**MEETING NOTES FROM
 WORKSHOP #4
 & SURVEY #4 RESULTS
 POSTED 11-01-2019**

THE MEETING NOTES IN THIS MARKUP OF THE WORKSHOP #4 AND SURVEY #4 GRAPHICS ARE COMPILED FOR THE PROJECT RECORD. IF THERE ARE ANY CORRECTIONS OR OMISSIONS PLEASE CONTACT THE PROJECT MANAGER.

Neighborhood Applicant Meeting & Workshop # 4

Striker Field Park

Parking and Park Access

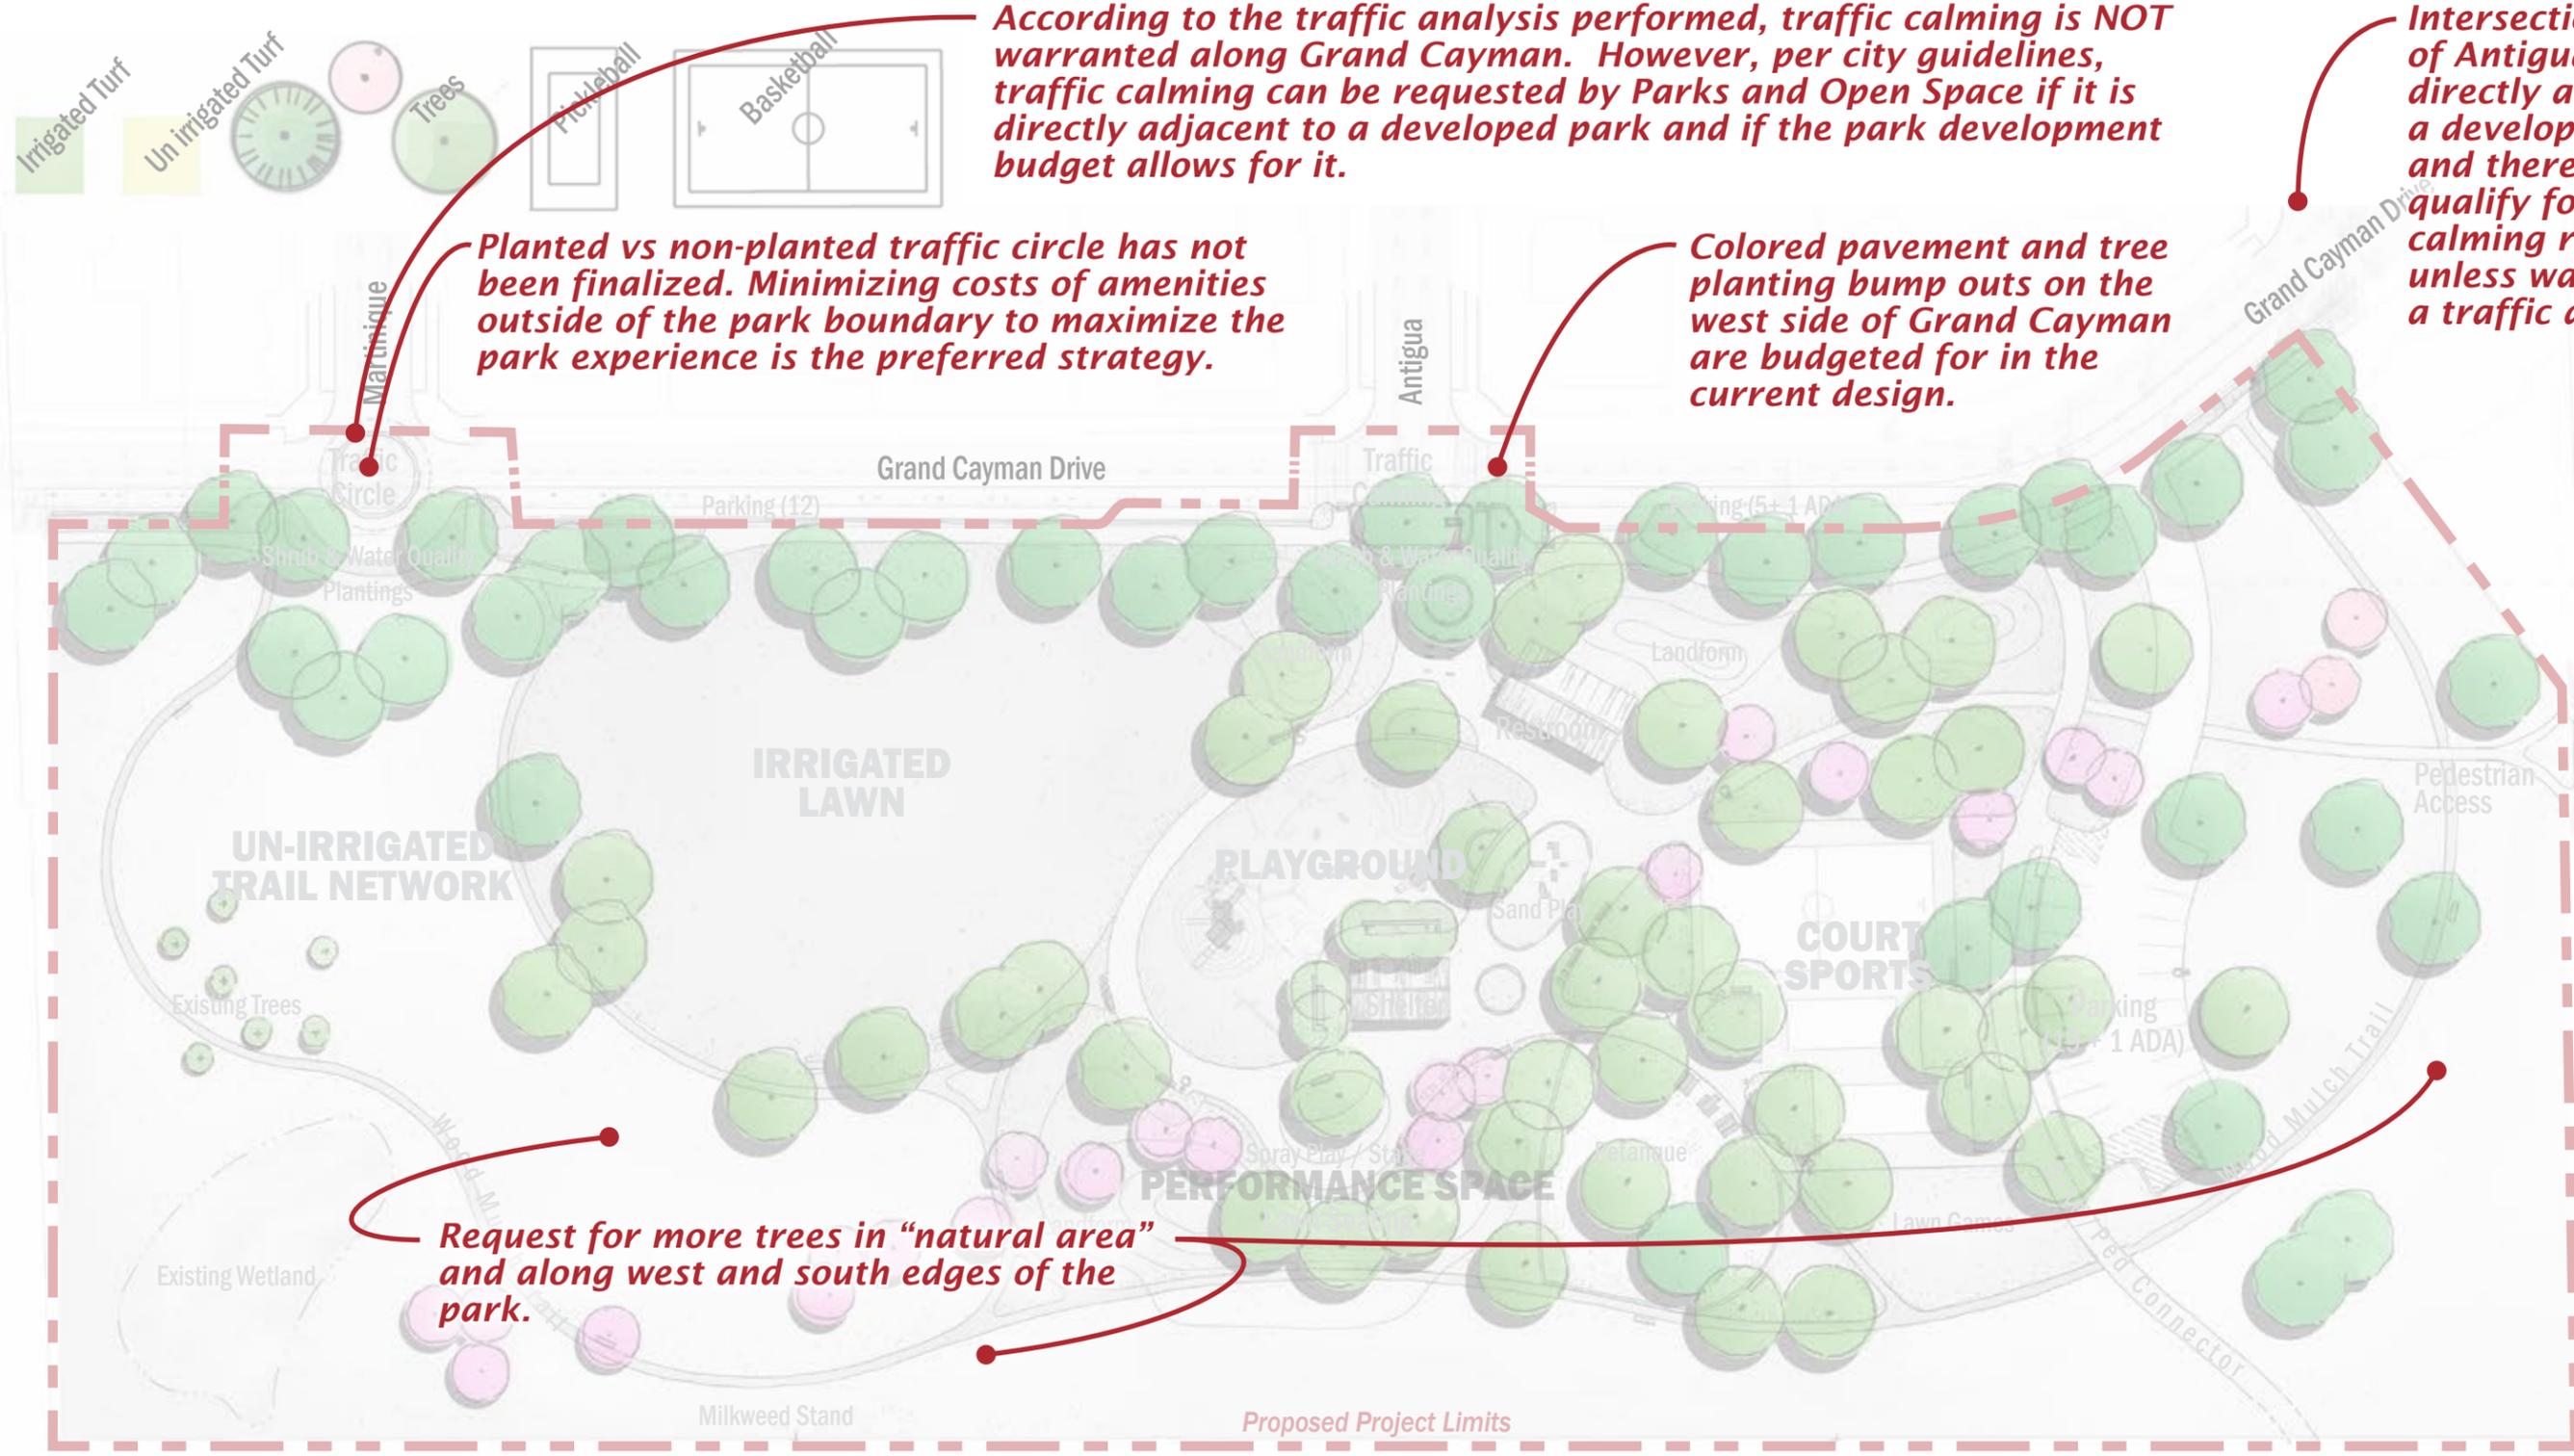
The temporary sidewalk extension to Shadow View (not shown) will be allowed by the landowner 4J School District, provided that the initial alignment and installation is paid for with the Striker Field park design and installation budget.

Clarification, this is both traffic calming and turn around and would meet all city and public emergency vehicular access needs if implemented.

The traffic calming measures shown are not required based on the transportation study and would need to be paid for with the park budget.

The value of this traffic calming measure is primarily for vehicle turn around.

Overall park budget needs to absorb the design, installation and maintenance costs of the traffic calming and parking shown.

Primary parking will be provided on the park site and accessed from Grand Cayman.

Design Concept - Informal Tree Layout

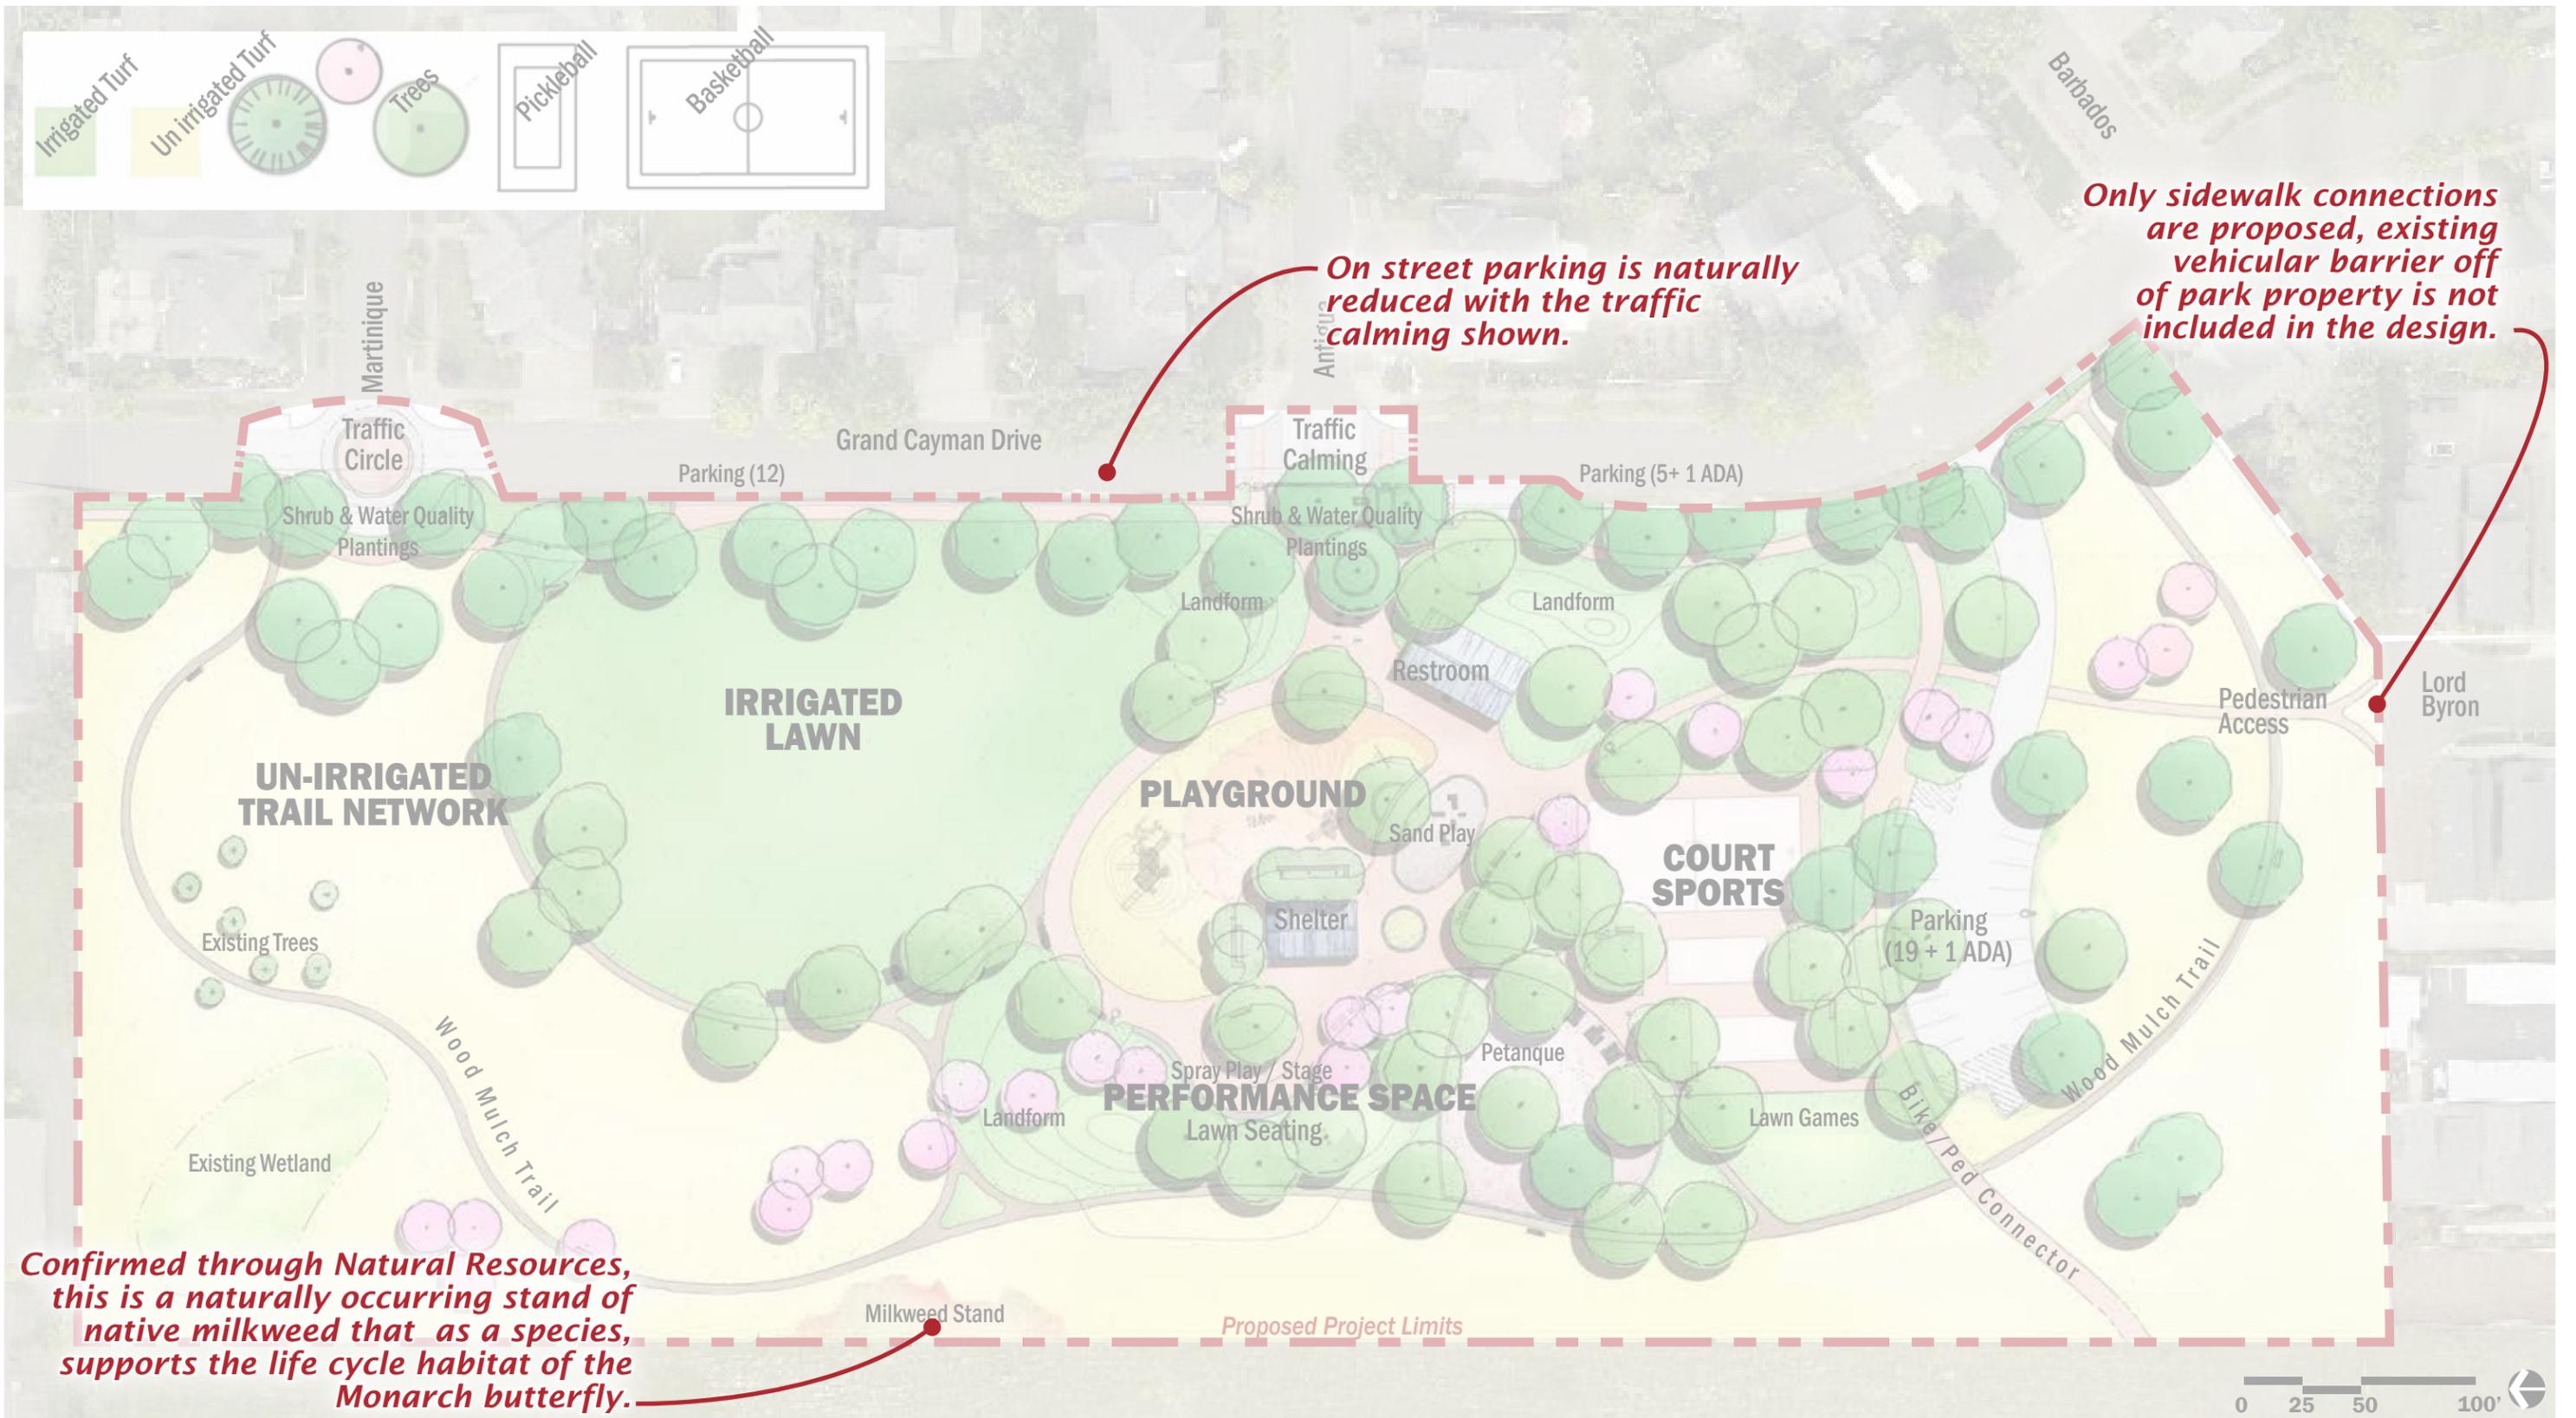
Request for more trees in "natural area" and along west and south edges of the park.

Materials & Furnishings Overlay

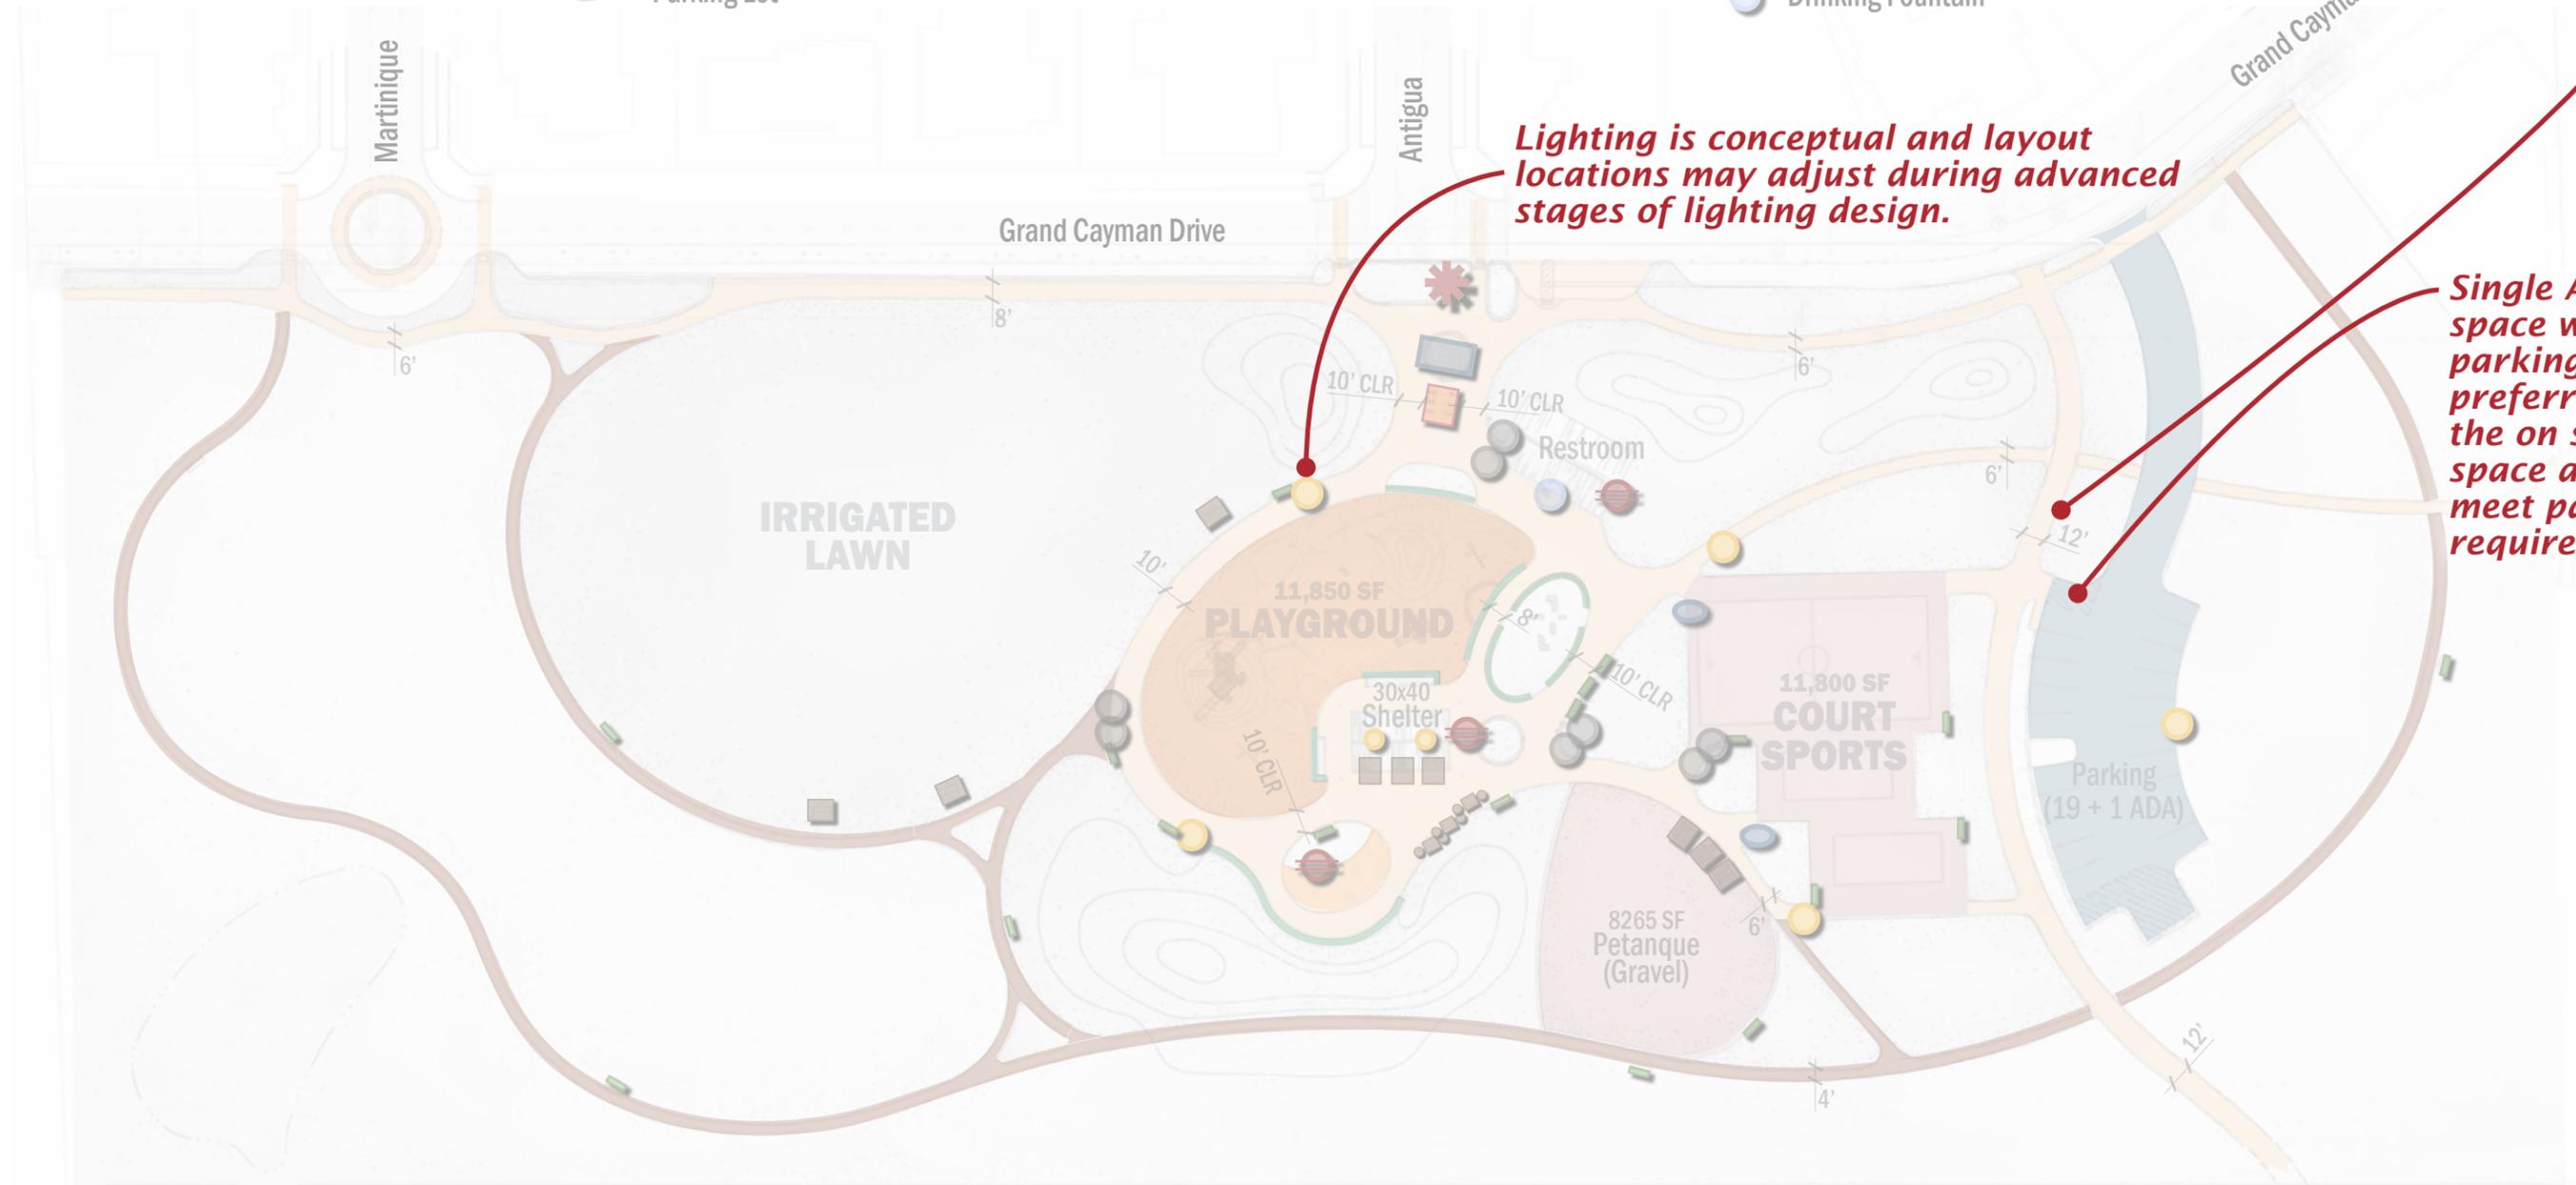
Wider paths are preferred for circulation and are shown at standard widths pending finalization of the park budget.

Lighting is conceptual and layout locations may adjust during advanced stages of lighting design.

Single ADA space within the parking lot is preferred over the on street ADA space and would meet parking requirements.
